Location of Construction: 115 Huntington Ave Lot 2		Owner: KTO Builders	Phone: 759-3813 0892-7813	Permit No.: 990047
Owner Address: 13 Varney Mill Rd Windham ME 04062		Lessee/Buyer's Name:	Phone:	BusinessName:
Contractor Name: SBA		Address:		Phone: 759-892-7813
Past Use: Vacant	Proposed Use: 1-Fam	COST OF WORK: \$ 60,000	PERMIT FEE: \$ 320	<div style="border: 2px solid black; padding: 5px; text-align: center;"> PERMIT ISSUED JAN 20 1999 CITY OF PORTLAND </div>
		FIRE DEPT. <input type="checkbox"/> Approved <input type="checkbox"/> Denied	INSPECTION: Use Group: R-3 Type: 5B BOCA 96 Signature: <i>[Signature]</i>	
Proposed Project Description: Construct 1-fam dwelling		PEDESTRIAN ACTIVITIES DISTRICT (P.A.D.) Action: Approved <input type="checkbox"/> Approved with Conditions: <input type="checkbox"/> Denied <input type="checkbox"/> Signature: _____ Date: _____		Zoning Approval: Special Zone or Reviews: <input type="checkbox"/> Shoreland <input type="checkbox"/> Wetland <input type="checkbox"/> Flood Zone <input type="checkbox"/> Subdivision <input type="checkbox"/> Site Plan maj <input type="checkbox"/> minor <input type="checkbox"/> mm <input type="checkbox"/>

RE: Certificate of Occu

SECTION 1014.6 TREADS & RISERS

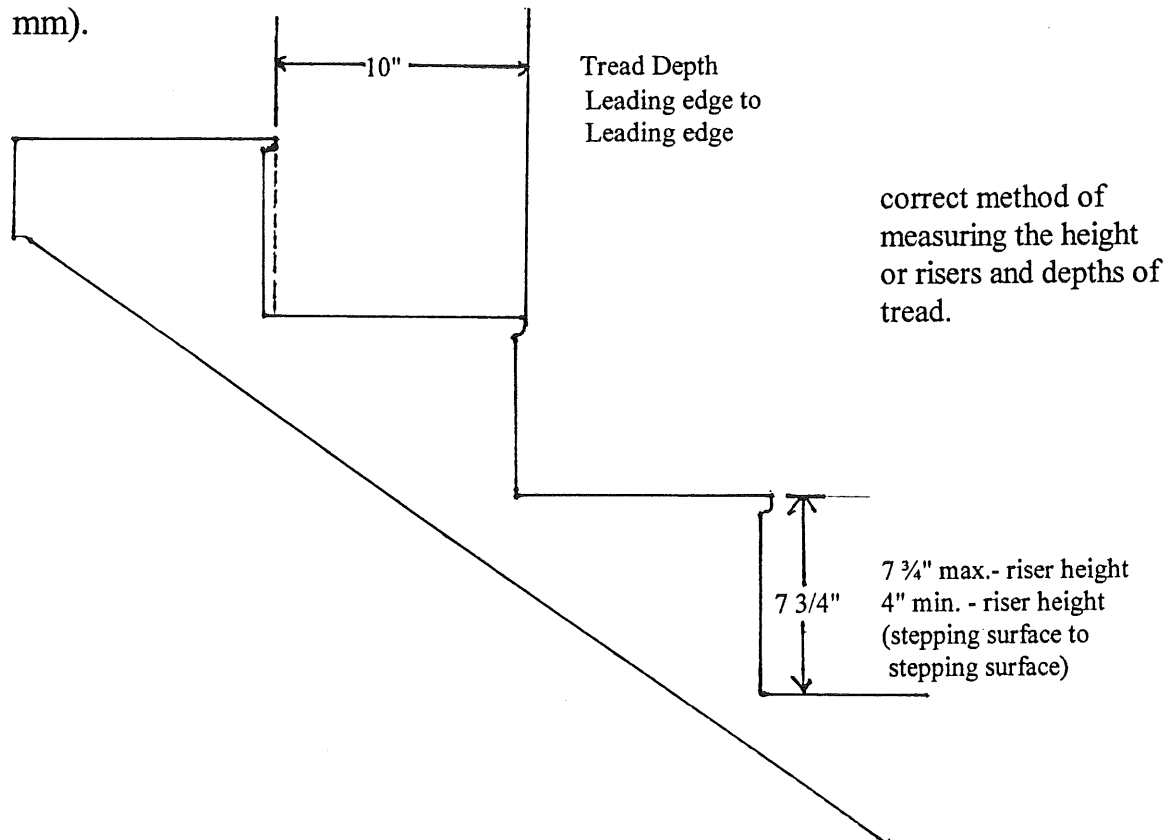
ENCLOSED IS COPY OF BOCA
96 SEC. 1014.6.8 & 1014.6.2
WHICH WE DISCUSSED ON 3/3
IN REGARD TO 115 HUNTINGTON
DUE (AS WELL AS ANY OTHER
R-3, R-2 OR U USE GROUP
CONSTRUCTION) - PLEASE NOTE
UNDER 1014.6.8 THE MAX.
RISE IS 7 3/4" UNDER
ANY CIRCUMSTANCE.

IN OTHER WORDS. ANY
GIVEN RISE COULD BE
7 3/4" (-) 3/16" BUT NOT
7 3/4" + 3/16" - TOTAL
VARIATION CANNOT
EXCEED 3/8" OVER
TOTAL STAIR RUN

WHEN COMPARING
THE ABOVE STANDARD
TO THE MEASUREMENTS
TAMMY TOOK @ 115 HUNT-
INGTON ON 3/3 IT IS
APPARENT THAT THOSE
STAIRS WILL NOT MEET
THE STANDARD.

copley woods lot 2
plot plan 1" = 20'

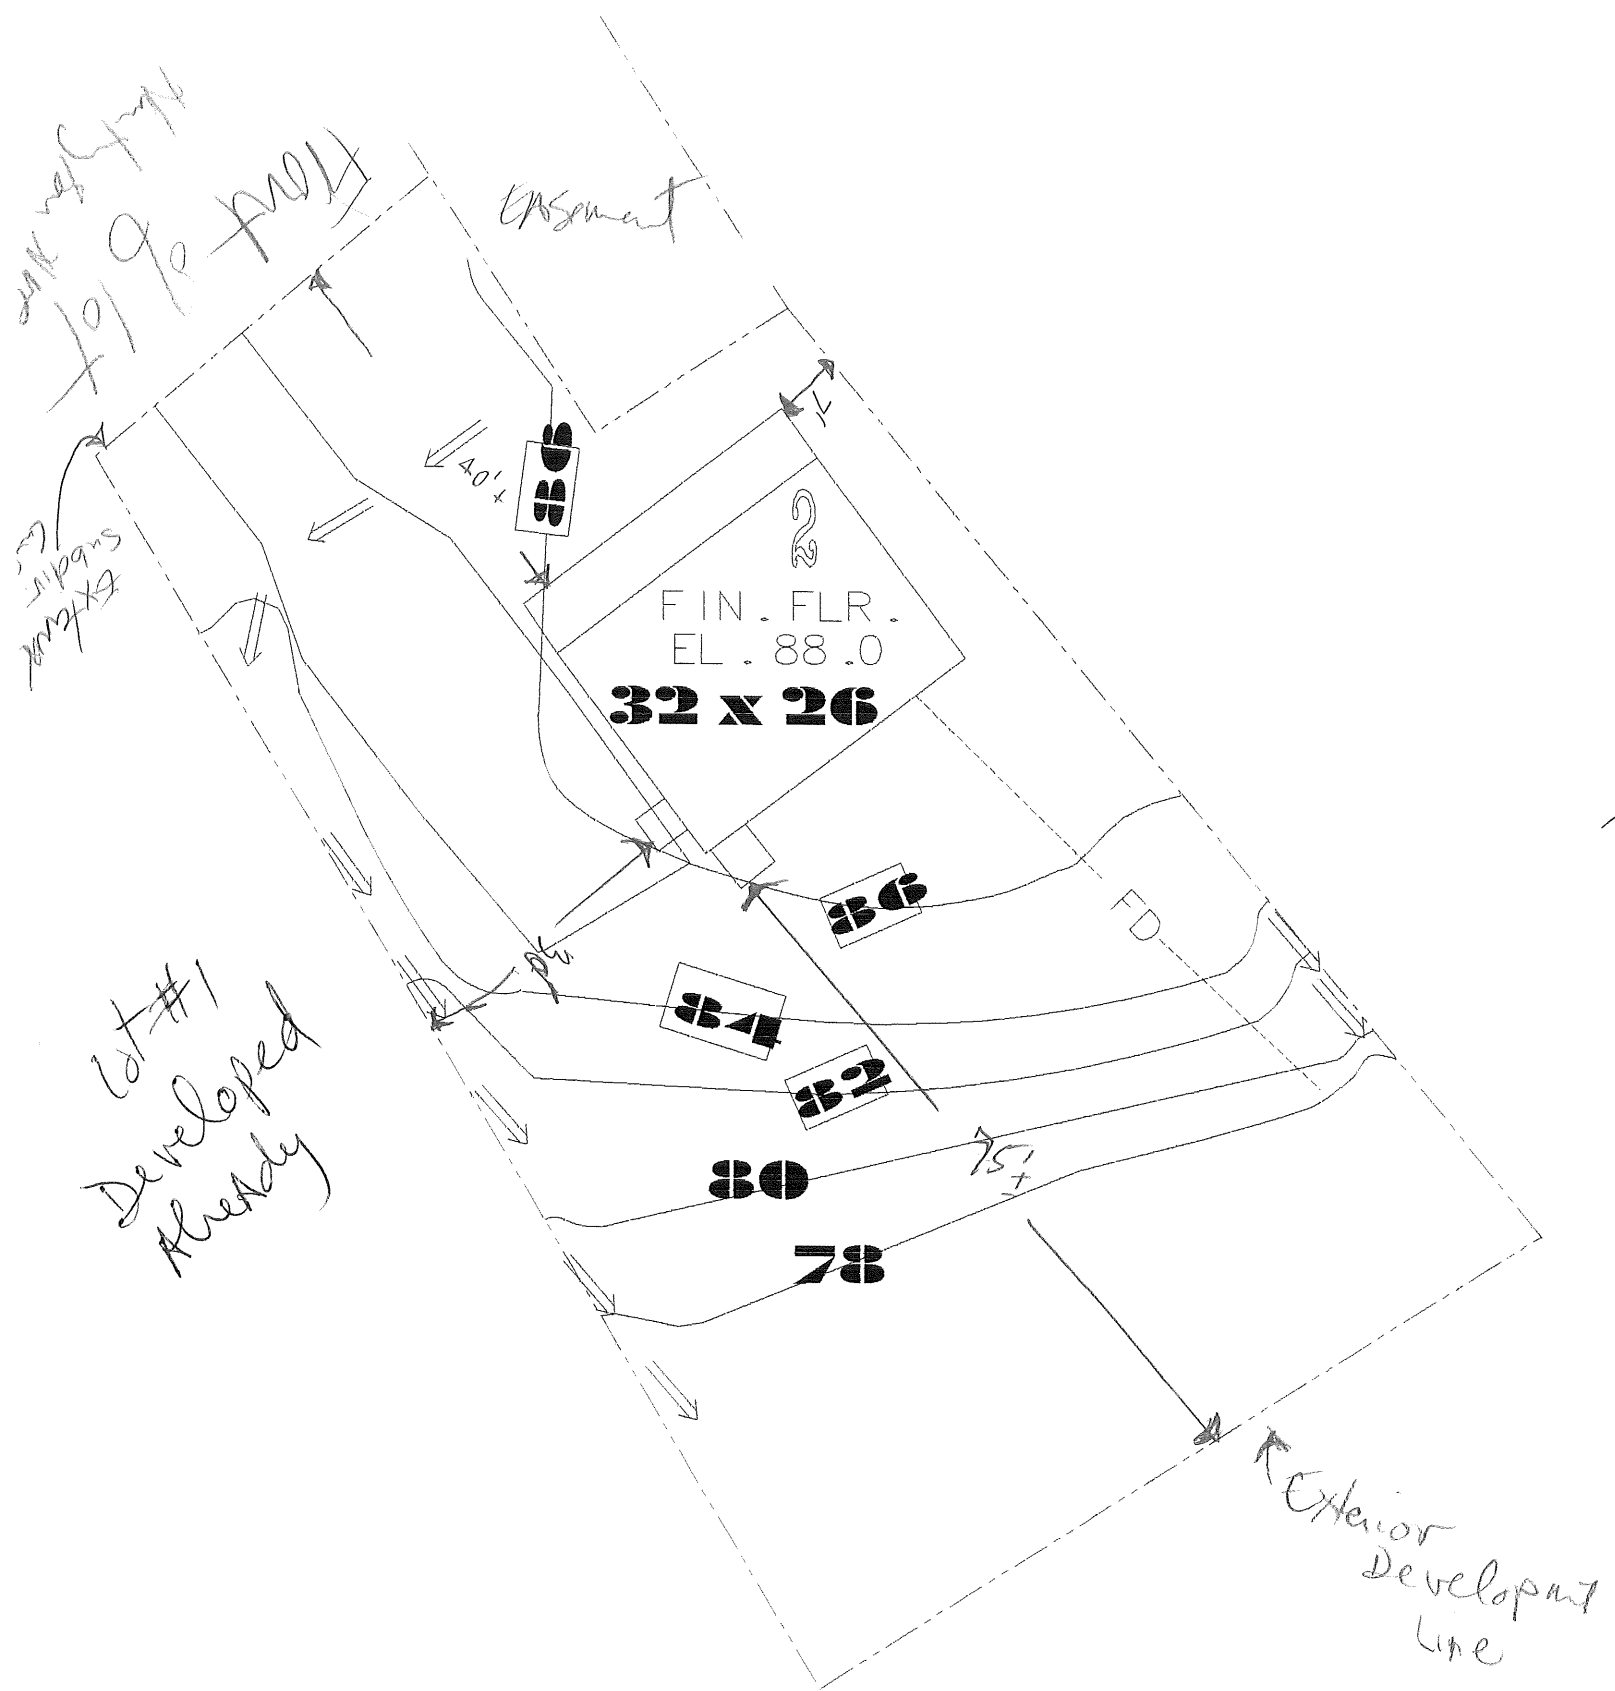
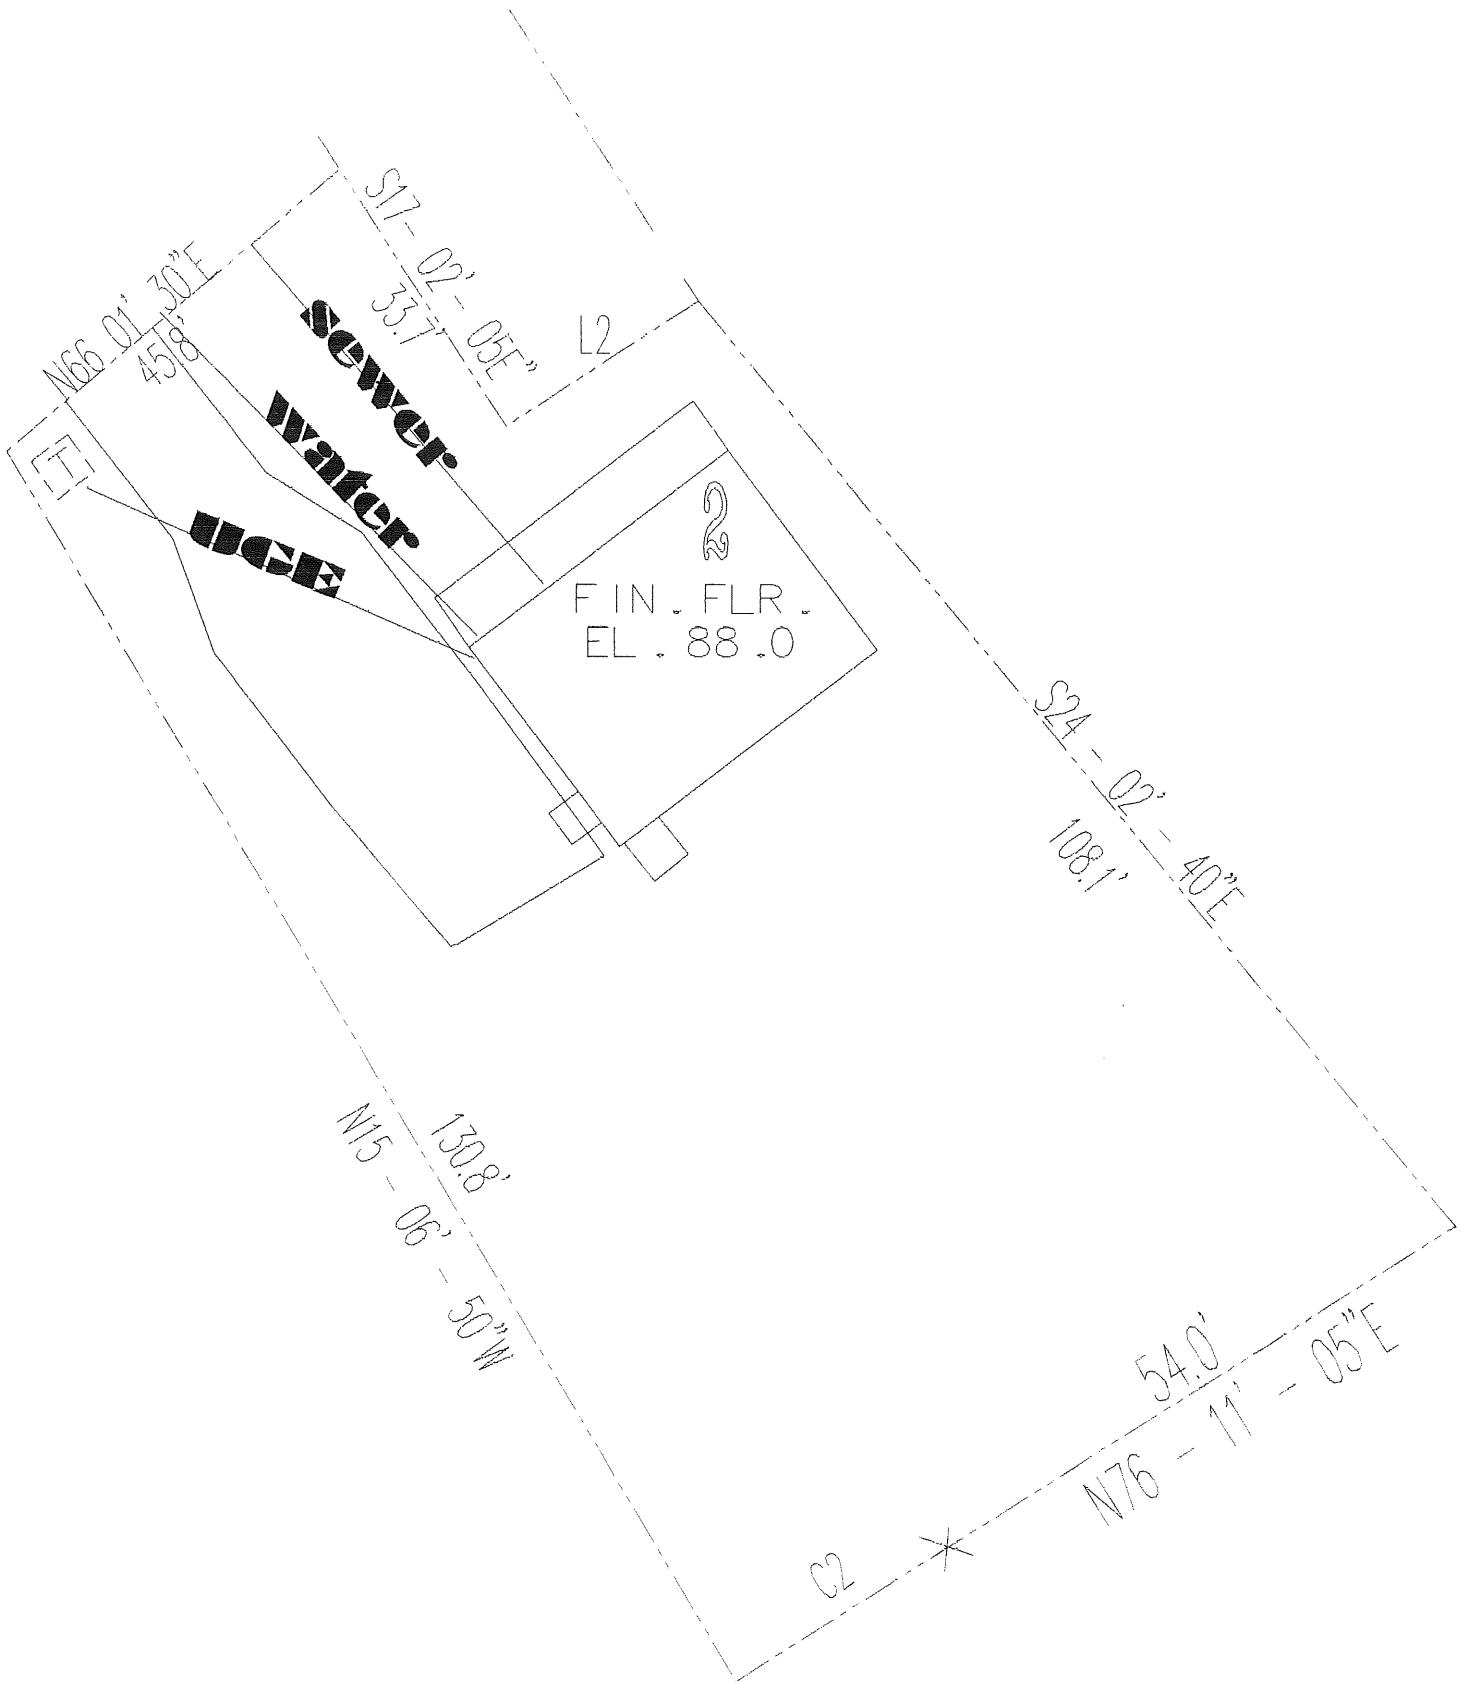
Off-street Parking - 2 req - 2 shown

Flood Plains - ~~N/A~~ Zone C in map 7/6/17
